PIC18F85J90 FAMILY

PIC18F85J90 Family Data Sheet Errata

Clarifications/Corrections to the Data Sheet:

In the Device Data Sheet (DS39770B), the following clarifications and corrections should be noted. Any silicon issues related to the PIC18F85J90 family of devices will be reported in a separate silicon errata. Please check the Microchip web site for any existing issues.

FIGURE 16-10: I²C™ SLAVE MODE TIMING (TRANSMISSION, 7-BIT ADDRESS)

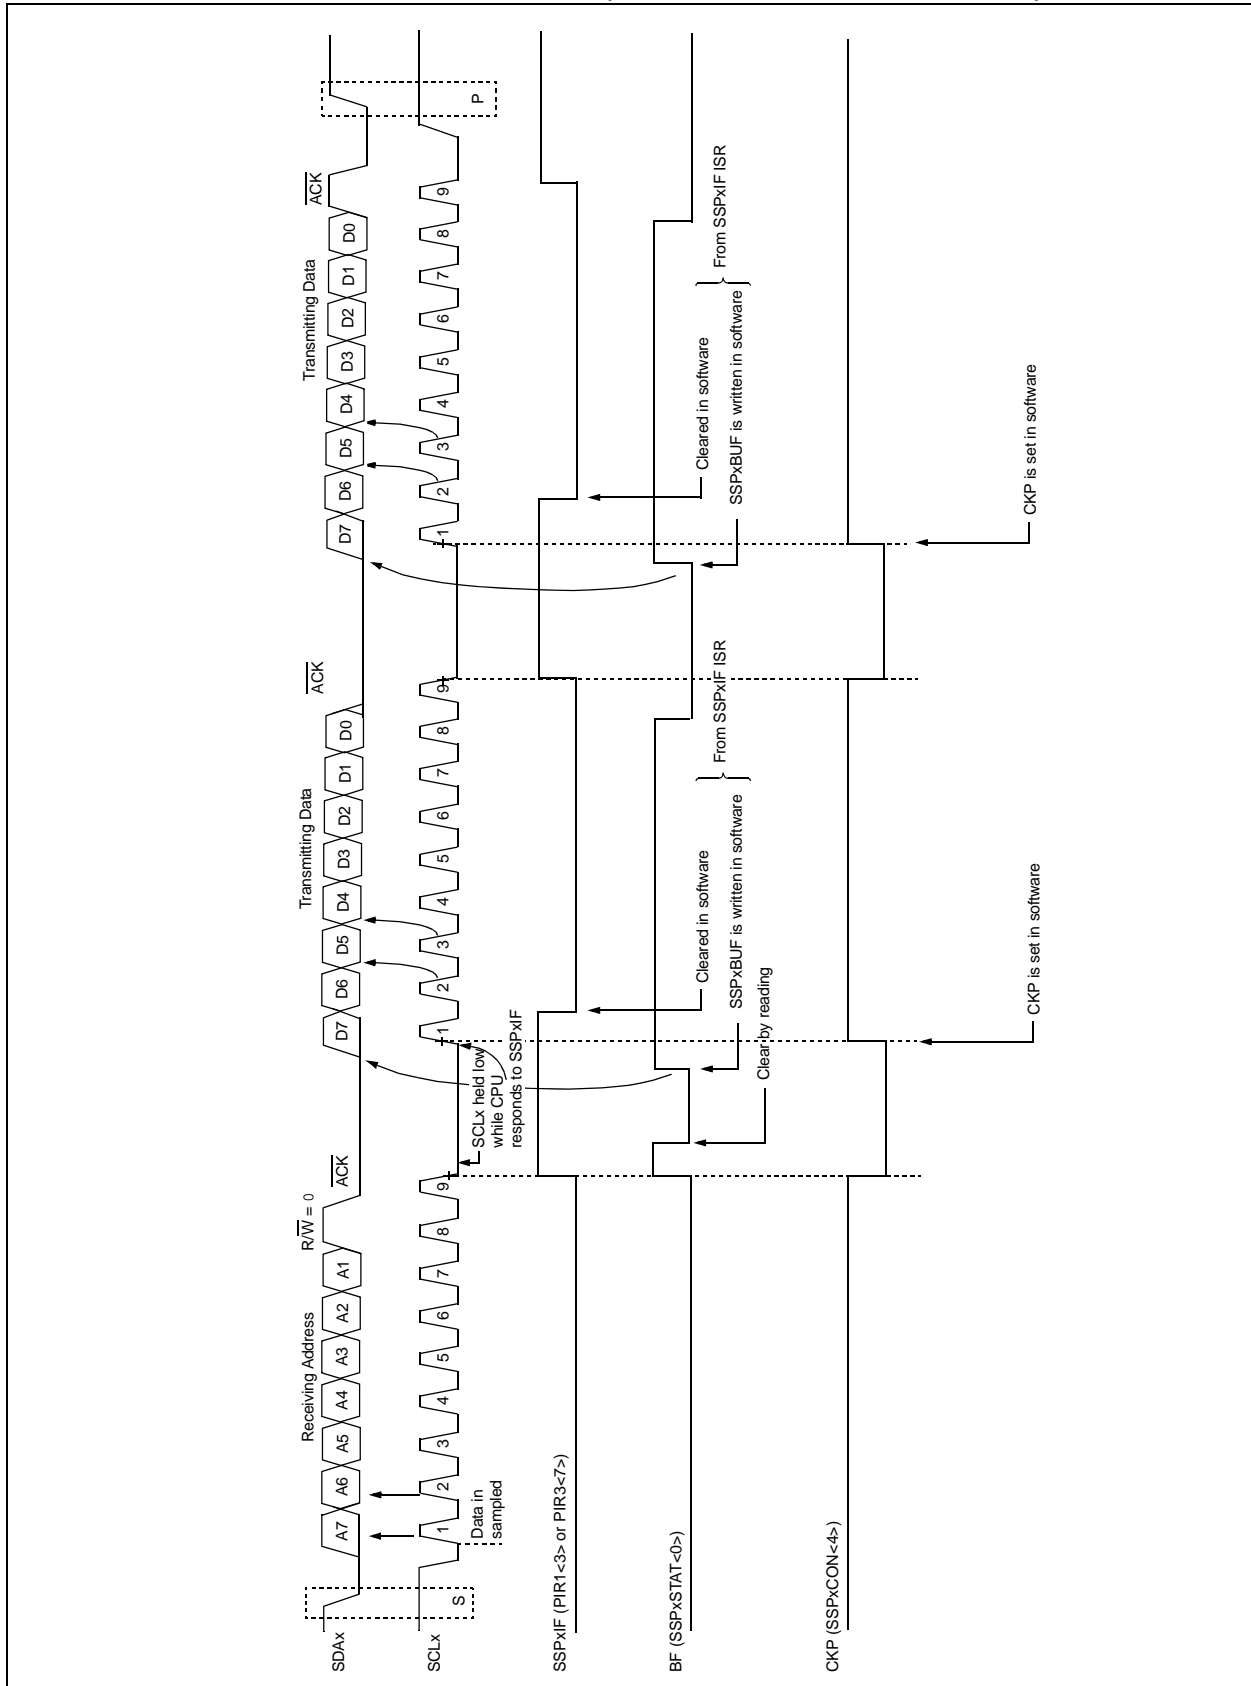
21. Module: Figure 16-10: I²C™ Slave Mode Timing (Transmission, 7-Bit Address)

On page 204, the figure is replaced with the new timing diagram provided in Figure 16-10.

FIGURE 16-24: I²C™ MASTER MODE WAVEFORM (RECEPTION, 7-BIT ADDRESS)

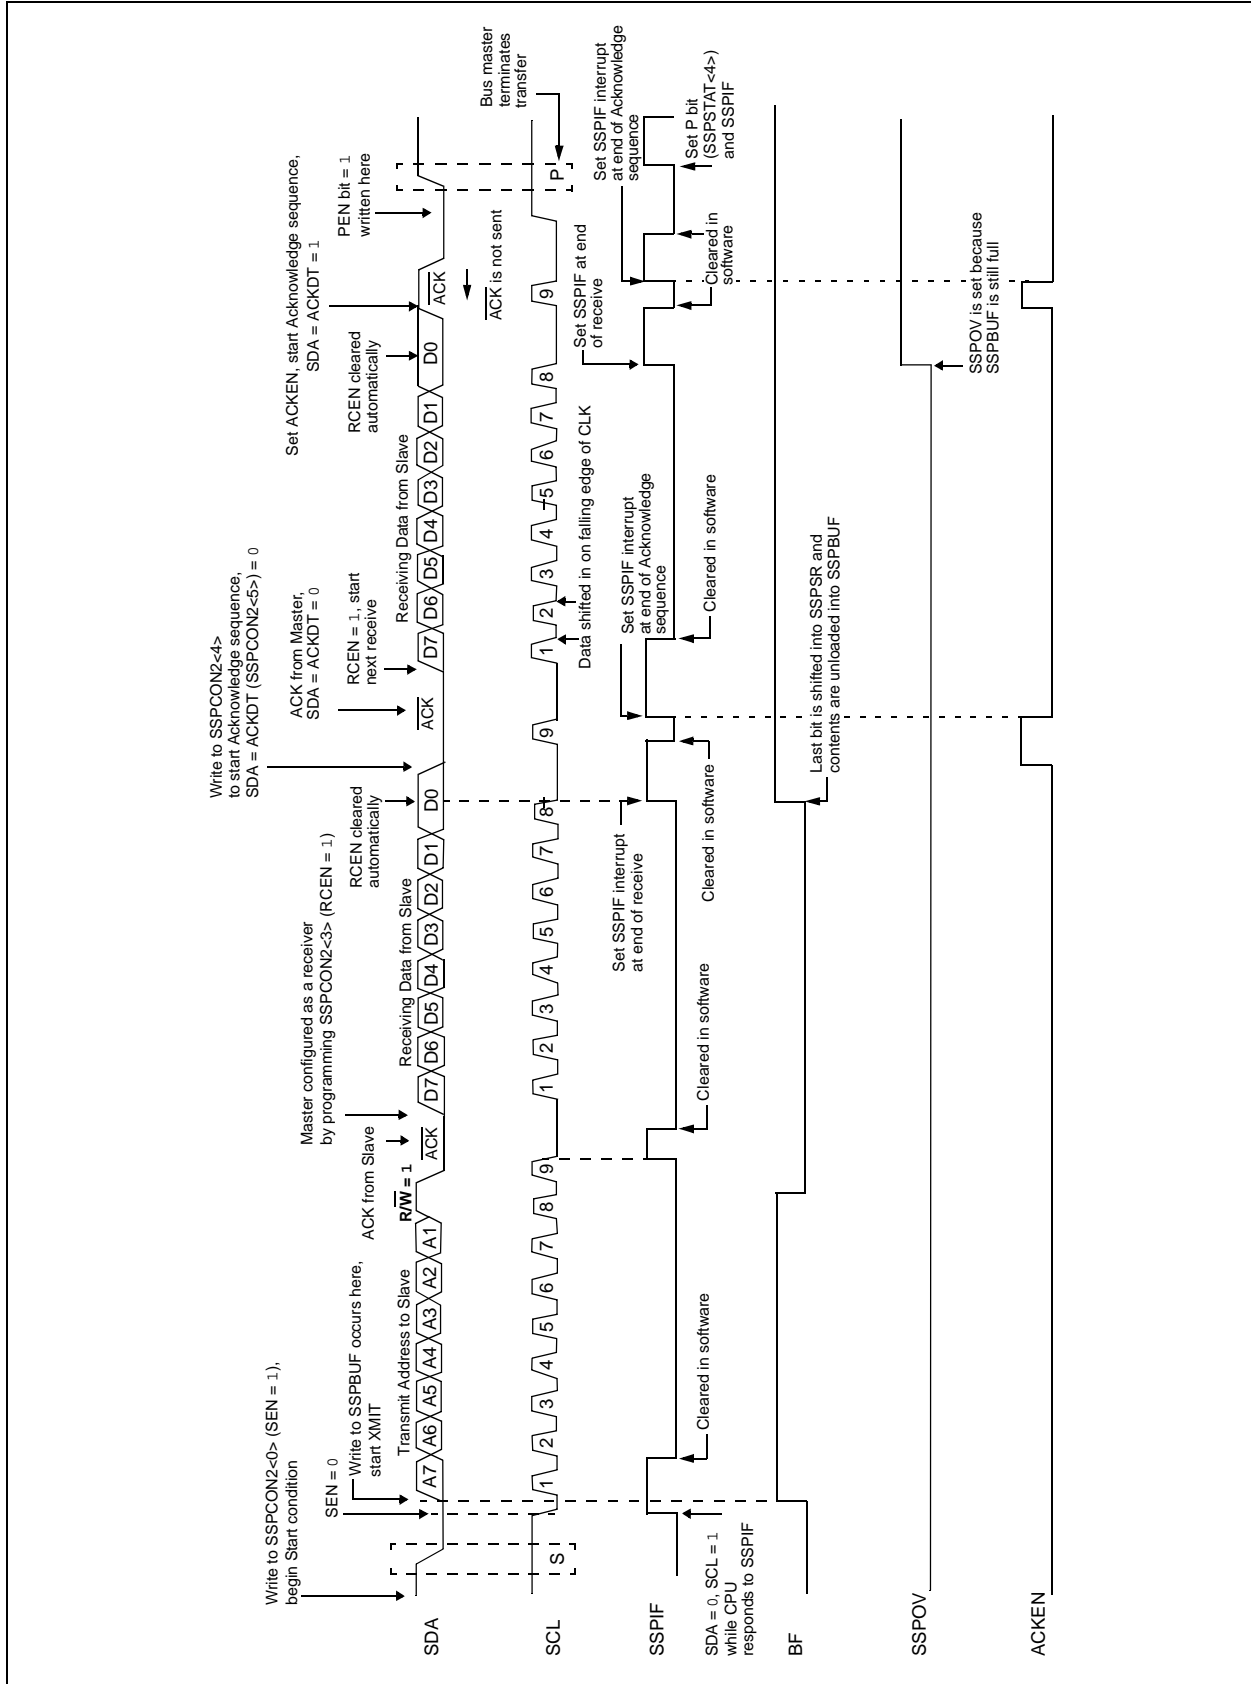
22. Module: **Figure 16-24: I²C™ Master Mode Waveform (Reception, 7-Bit Address)**

On page 221, the condition (R/\overline{W}) when the Acknowledge signal (ACK) is received from the slave, after transmitting the address to the slave, is changed to '1'. The changed value is indicated in bold text in Figure 16-24.
